New position of the fuel tank and airbox drain hoses CR156

SuperSport Model Year 2017-2018

Recall Service Bulletin SRV-RCL-18-003

Following quality tests performed on the above-mentioned motorcycles, we noticed potential contact between the fuel tank and/or the airbox drain hoses with the horizontal cylinder exhaust manifold. In rare circumstances this contact could create a fire hazard in the motorcycle lower LH area (under the battery). To avoid this issue, we have defined a new routing for the fuel tank and airbox drain hoses to prevent contact of the drain hoses with the horizontal cylinder exhaust manifold.

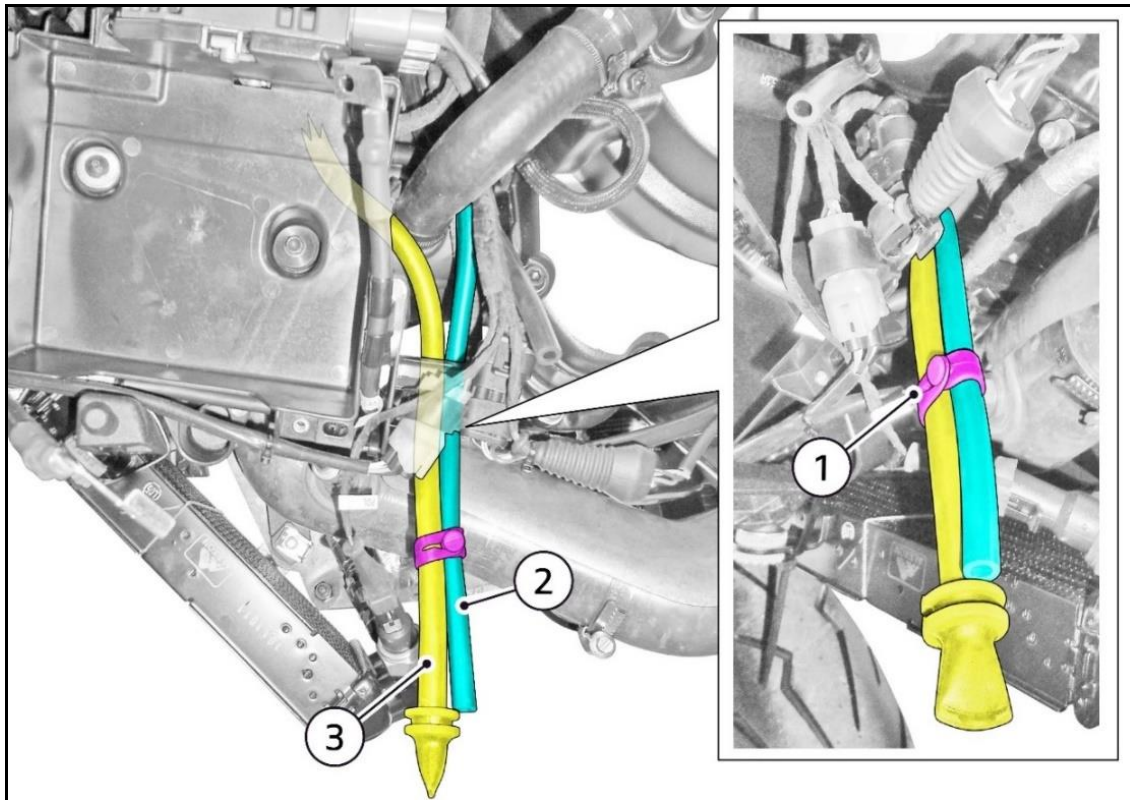
- 1.0 Remove LH side fairing (See "Section 05 - Faring" of the Workshop Manual)
- 2.0 Remove and retain the **L.39 mm button tie (1)** part no. 74110551A that secures the **fuel tank drain hose (2)** and the **airbox drain hose (3)**

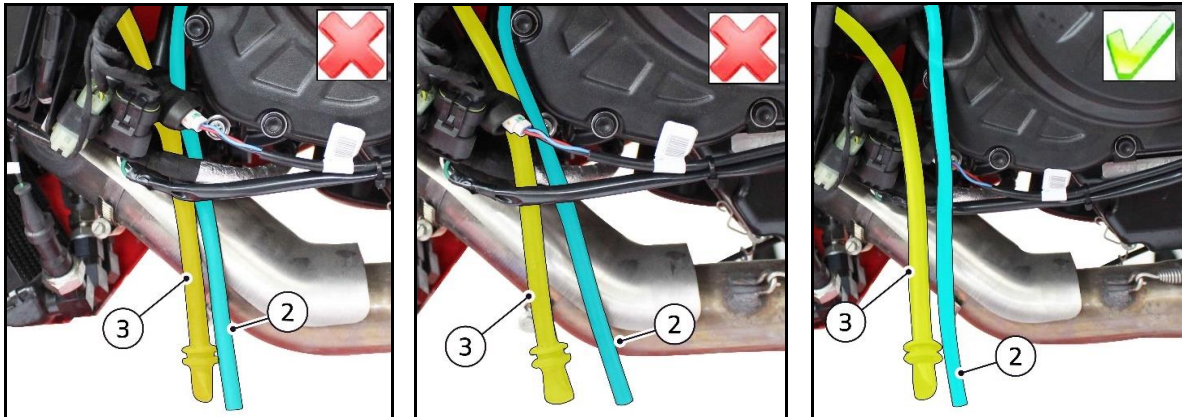
- 3.0 Use a felt-tip pen to mark the coolant expansion reservoir drain hose (A) at 20 mm measured from the free end, as shown in the figure

- 4.0 Cut hose (A) on the mark previously made with the felt-tip pen

Before performing the cut, make sure that the marked **hose (A)** is the coolant expansion reservoir drain hose

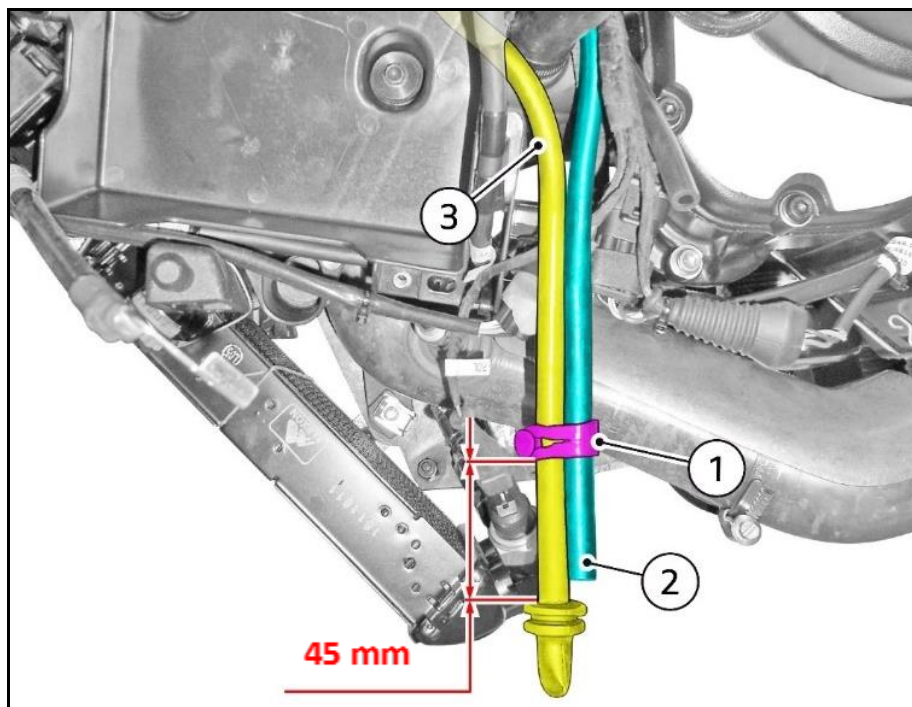
5.0 Reposition the **fuel tank drain hose (2)** and **airbox drain hose (3)** outside the starter motor, the side stand and the Ducati Quick Shift (DQS) cables, as shown

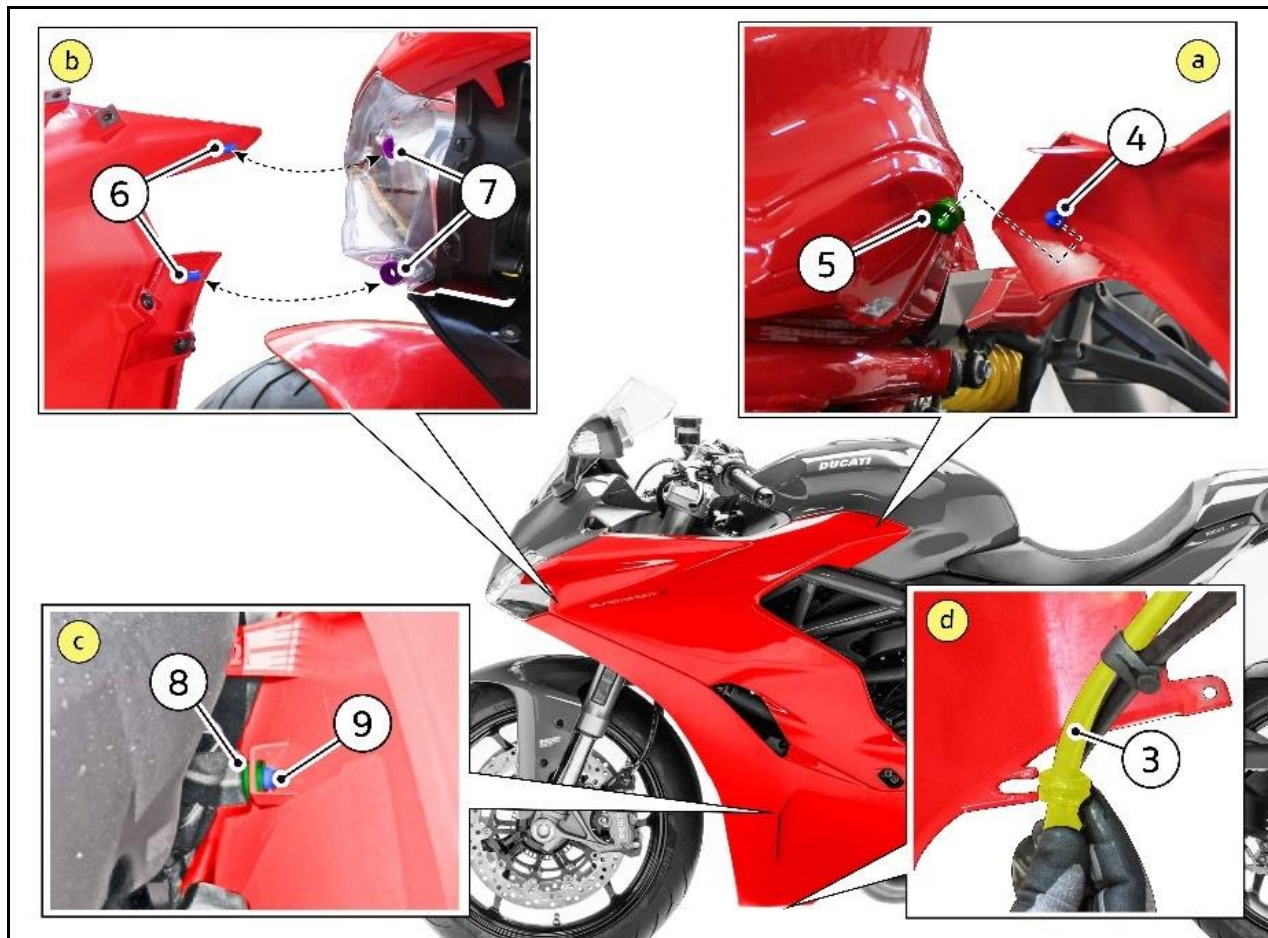
6.0 Fit the **L.39 mm button tie (1)** and position it at **45 mm** measured from the upper edge of the groove on the **airbox drain hose (3)** terminal, as shown

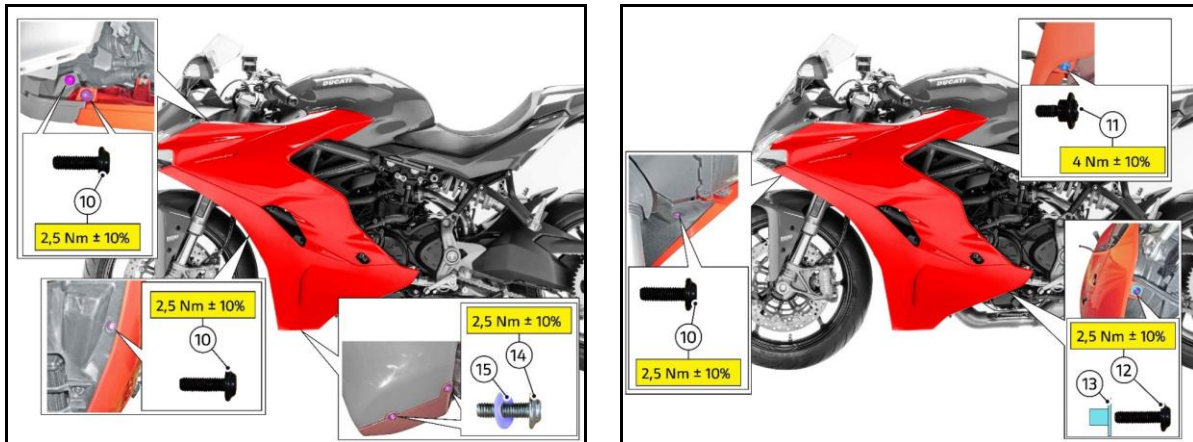
8.0 To fasten the LH side fairing, tighten the screws indicated below to the specified torque:

- A. 4 M5x12 screws (10) to $2.5 \text{ Nm} \pm 10\%$**
- B. 1 M5x9 screw (11) to $4 \text{ Nm} \pm 10\%$**
- C. 1 M5x18 screw (12) with spacer (13) to $2.5 \text{ Nm} \pm 10\%$**
- D. 2 M5x16 screws (14) with washer (15) to $2.5 \text{ Nm} \pm 10\%$**

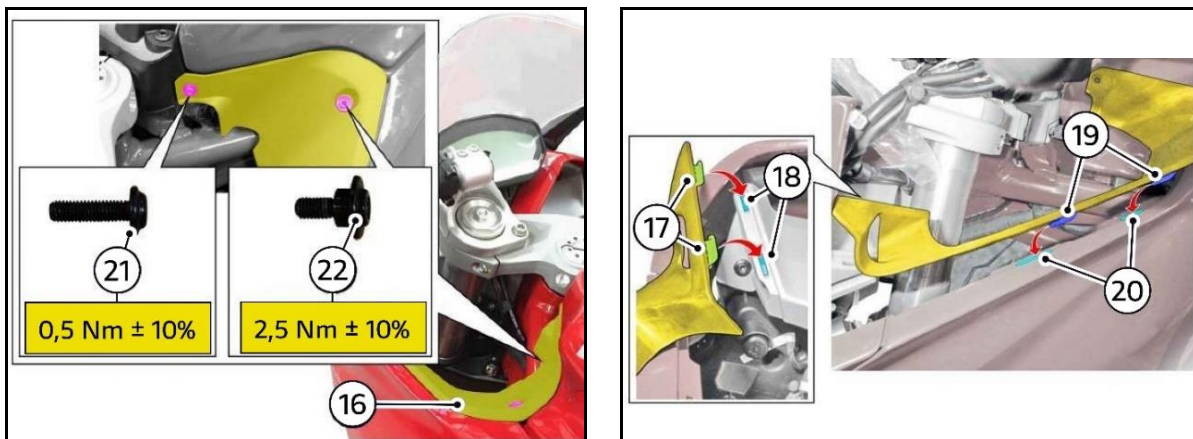
9.0 Position the **LH cover (16)** by engaging the **2 front teeth (17)** in the **slots (18)** of front subframe and the **2 teeth (19)** in the **slots (20)** of the LH fairing

10.0 Tighten the **M5x18 screw (21)** to $0.5 \text{ Nm} \pm 10\%$ and the **M5x9 screw (22)** to $2.5 \text{ Nm} \pm 10\%$
